# **Response to NRC Post-Fukushima Recommendations**

## **1D Response to NRC Post-Fukushima Recommendations**

### **1D.1 Introduction**

Figure 2.2.6 Remote Shutdown System

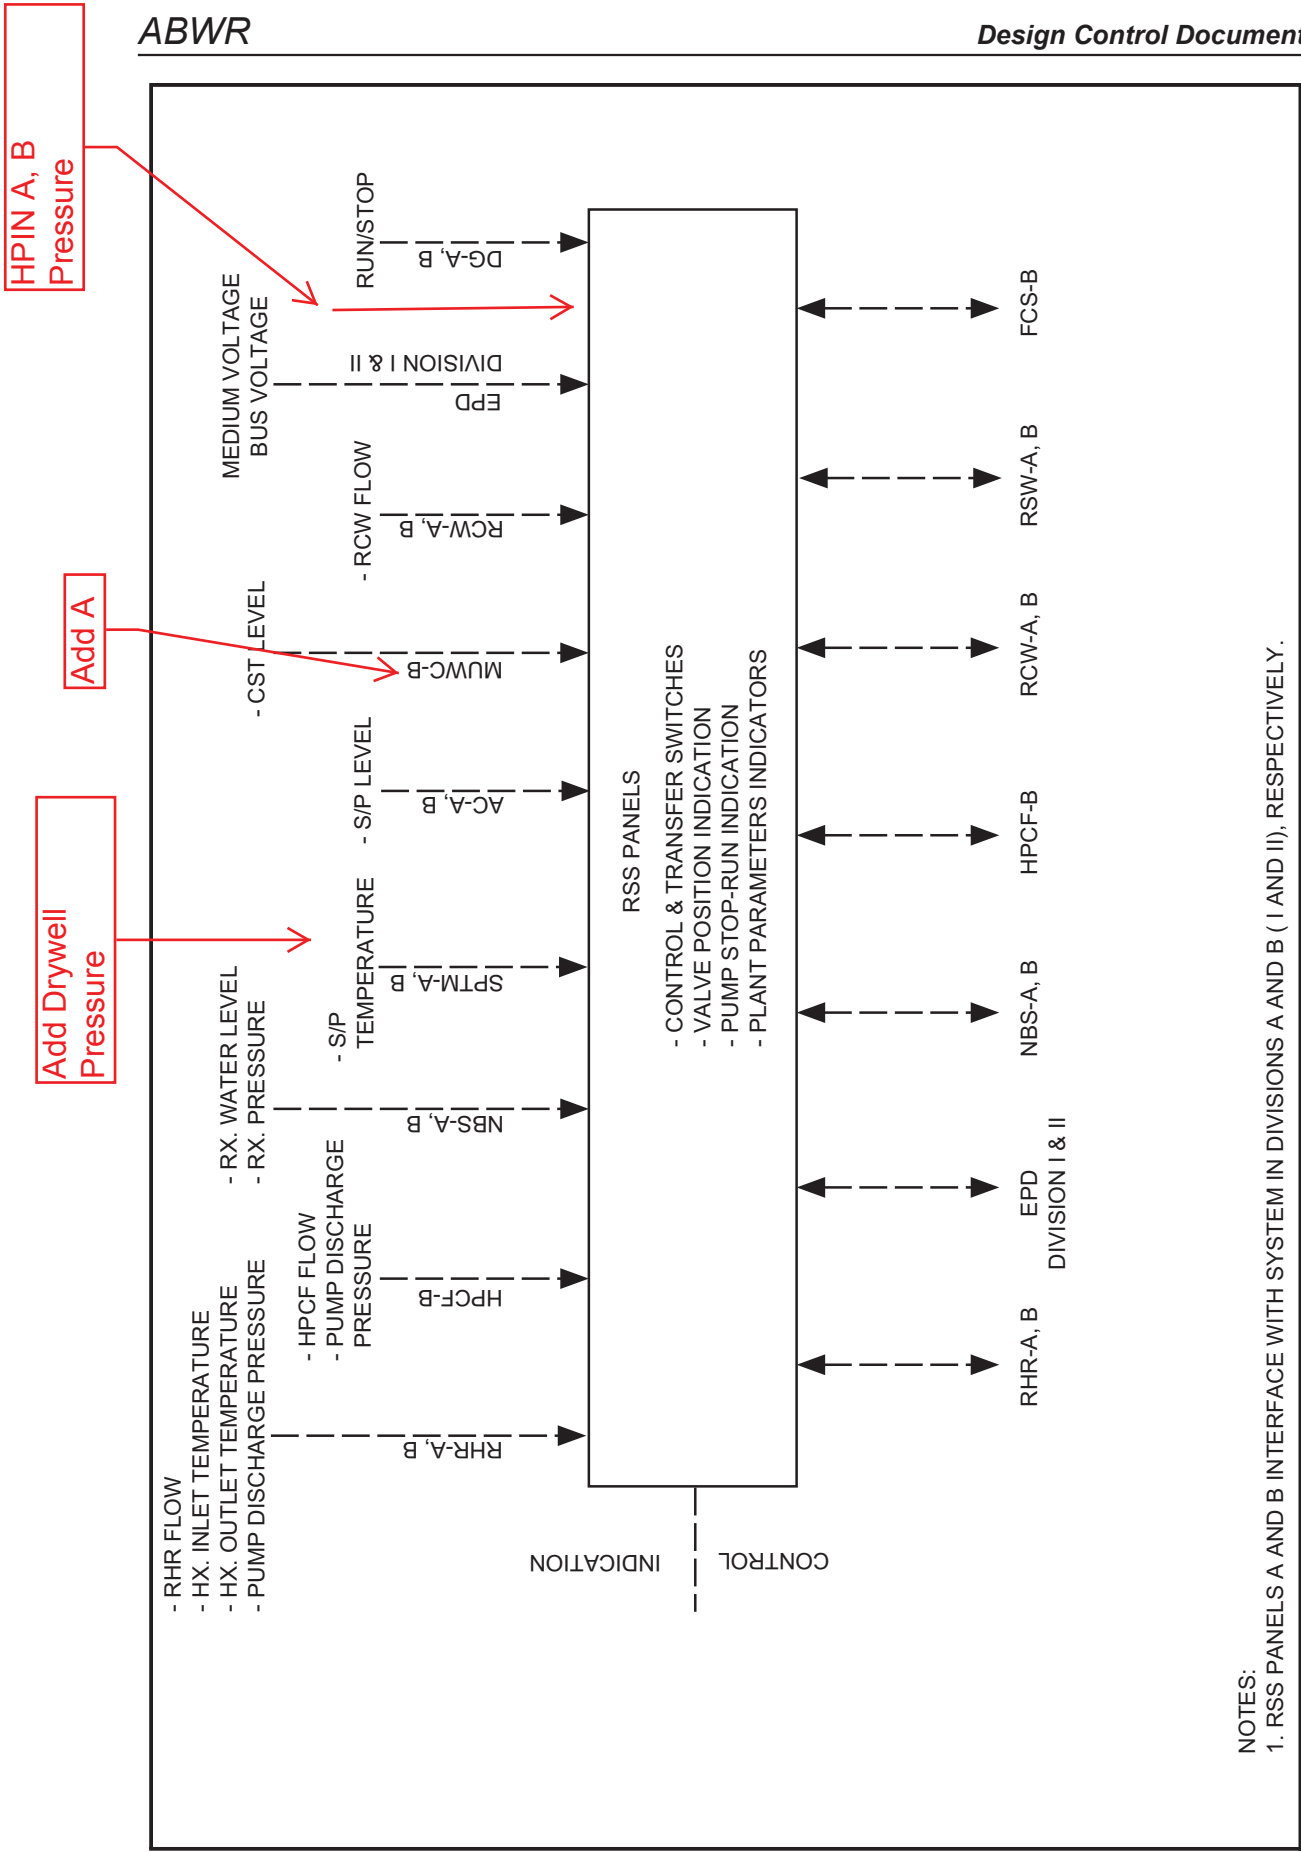
(12) High Pressure  
Nitrogen Gas  
Supply System

NOTES:  
1. RSS PANELS A AND B INTERFACE WITH SYSTEM IN DIVISIONS A AND B ( I AND II), RESPECTIVELY.

Figure 7.4-2 Remote Shutdown System IED

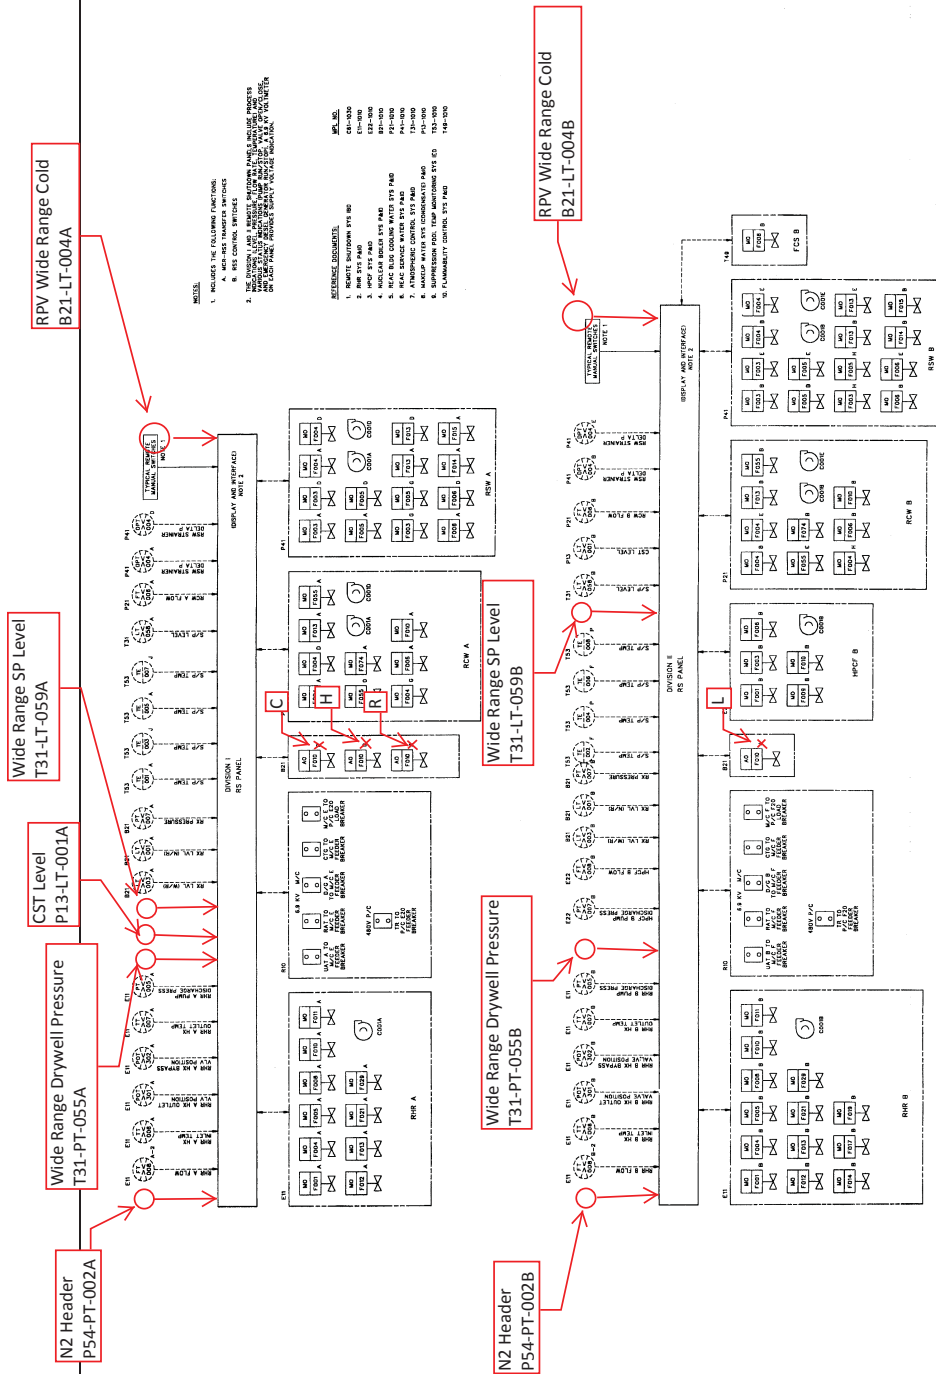
- Added Reactor Building (RB) external connections for FLEX diesel generators to 480VAC RB 1E power centers.
- Replaced control of SRVs G, J, K, and P with Control of ADS SRVs C, H, L and R on the Remote Shutdown Panel (RSP)

- Added Wide Range RPV Water Level indication (Division I and II) (Cold Calibration) to the RSP.
- Added N2 Supply Header Pressure indication (Division I and II) to the RSP

- Added CST Water Level indication (Division I) to the RSP
- Added Containment Wide Range Pressure indication (Division I and II) to RSP
- Added Wide Range Suppression Pool Water Level indication (Division I and II) to the RSP
